Temp Transformer Replacement in Slidedriver, StrongArm, HydraSupply

SUBJECT: Temporary replacement of transformer (P/N MX000486) with modified part (P/N MX5657-xxx).

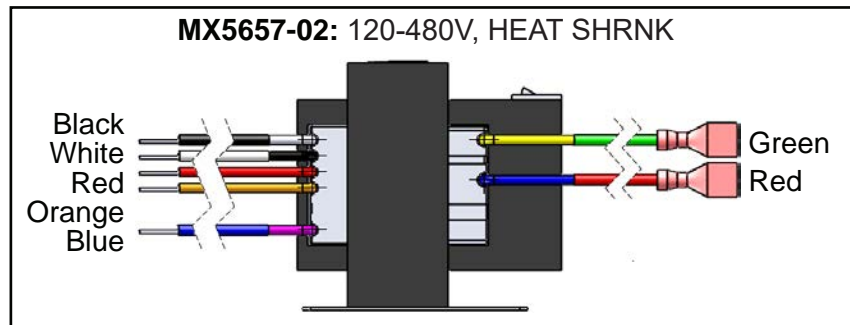
MX5657-02 is the *modified* replacement transformer for MX000486 in HydraSupply, StrongArm, and SlideDriver (excluding X2/X3 models). Diagram at right shows modified wire colors. The wires are colored with heat shrink to match current units.

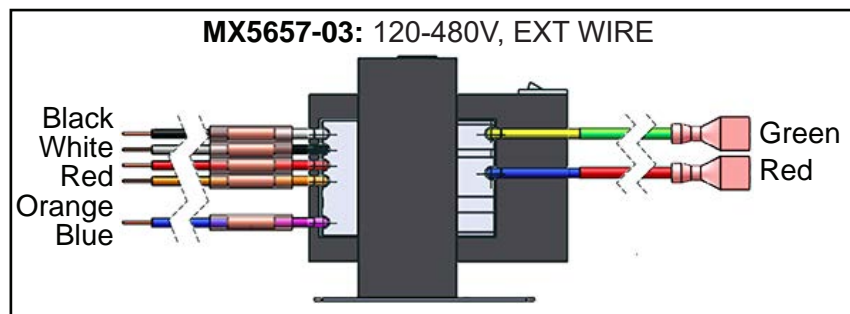
MX5657-03 is the *modified* replacement transformer for MX000486 in SlideDrivers with VFDs (X2/X3 Models). Diagram at right shows modified wire colors. The wires have been cut and spliced to make them the proper length and color.
